MARSH ISLAND

(A) APARTMENT HOUSE ZONE  
APPLICATION FOR PERMIT

Subject: Building permit for construction of 2-room  
dwelling house on Marsh Island, off ocean side  
of Long Island

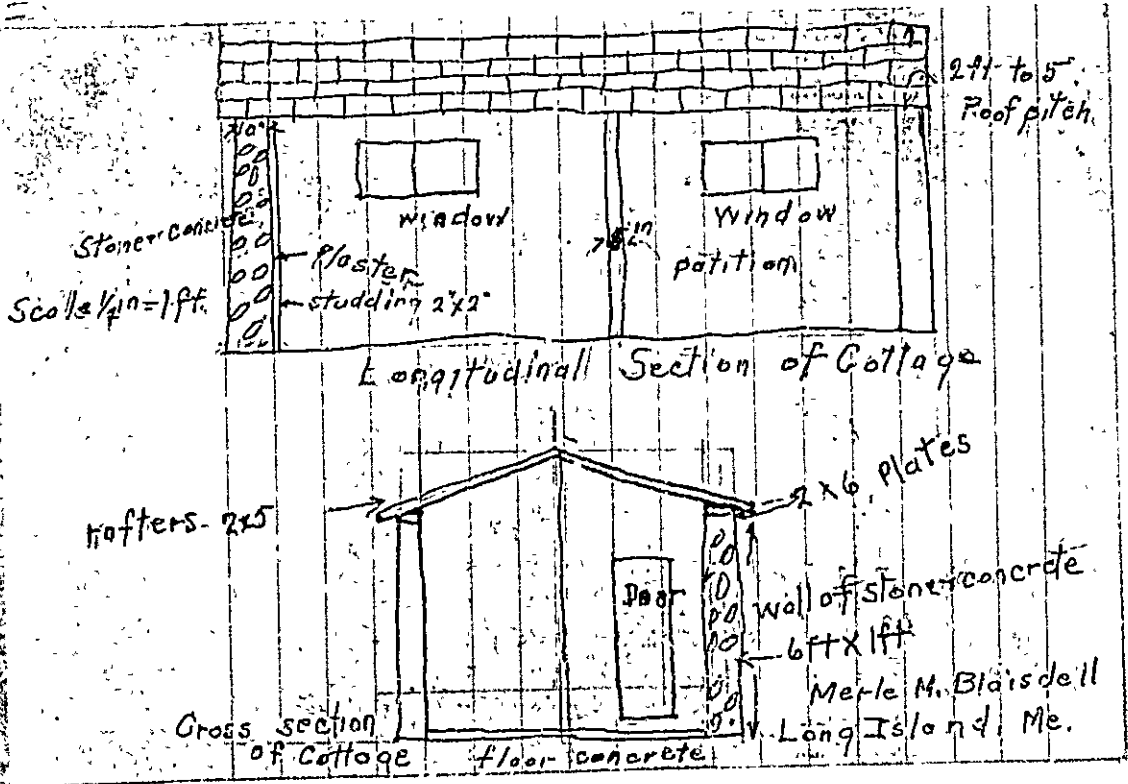
1. It is understood that the exterior walls of stone masonry are to get their bearing directly upon solid ledge sufficiently flat to give stability, and that the floor of the building is to be of concrete bearing directly upon the ledge with sufficient sand cushion beneath to make the floor level.

2. The stone masonry walls are required to be no less than 16" thick by Section 309b of the Building Code, each stone is required to be well bedded and openings slushed full of mortar composed of one part of lime putty, one part of Portland cement and not more than six parts of sand by volume. Of course straight cement mortar may be used which shall be composed of one part of Portland cement and not more than three parts of sand by volume with enough lime putty or hydrated lime added to make the mixture more easily workable. The stones are thus to be laid in mortar rather than laid up dry and concrete poured in or pointed up, working into the joints afterwards as you told me you originally intended. These stone walls are required to have bond stones extending sufficiently through the wall to tie it together and spaced no more than 3' apart both horizontally and vertically.

3. The wooden plate at the top of the wall is required to be bolted to the stone masonry, and, ~~if there is any stone masonry~~, and, if there is any stone masonry over the heads of the windows and door, steel members of adequate size and sufficient strength are required to span from jamb to jamb of the opening.

4. A copy of your application giving some of the details to which you have agreed is enclosed with the permit and this letter. In addition a ridge board is required between beveled ends of the rafters at the peak of the roof, and it will be necessary to provide ties across the building from plate to plate at the base of the rafters. These may be ceiling joists if a ceiling is to be provided, but strapping should be run the other way unless these ties are to be spaced no more than 16" from center to center.

5. You have indicated the chimney to be of stone also, and this <sup>chimney</sup> is required to have walls no less than 12" in thickness, and laid up in the same manner as for the exterior walls. The chimney requires a tile flue lining from the bottom of the flue to the top, and requires a cast iron cleanout door and frame at the very bottom of the flue. Where the chimney goes through the roof, the roof framing should be framed out so that no part of the woodwork will be closer than one inch to the exterior of the chimney wall and, the opening properly "rashed" into the roofing. The chimney is required to extend at least 2' above the highest point at which it becomes in contact with the roof and at least as high as any roof surface within 17', measured horizontally.

P.S. Apparently, there is to be only one interior partition, and that is non-bearing. This partition is required to be framed with no less than 2x3 studs, set upright, supported on a shoe at the floor and similarly at the ceiling.
